WATERS Weekly FPY review (WW43 – 2018)

Agenda

Sample 3 (20x magnification)

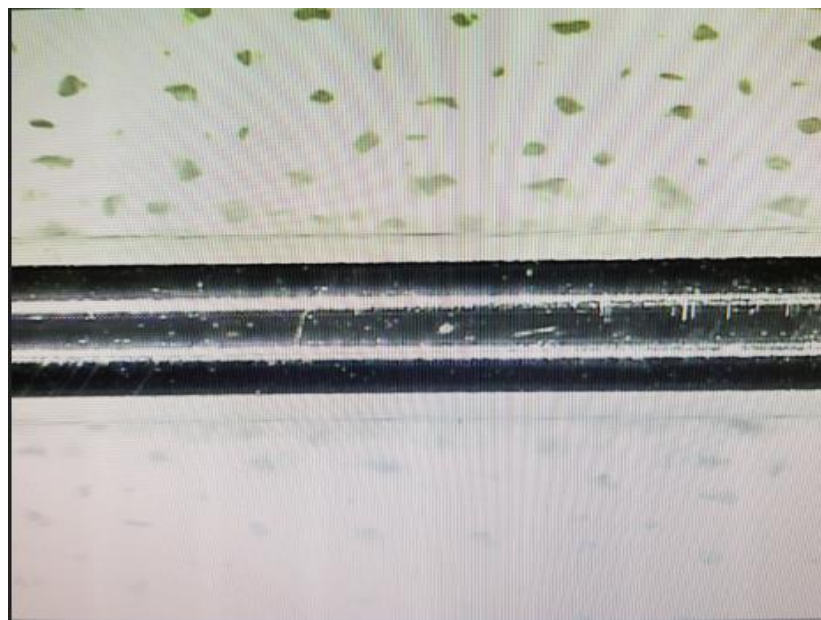
- Needle tip is checked for pit mark Unable to detect pit.

- Needle body is also checked for longitudinal scratches. No scratches found.
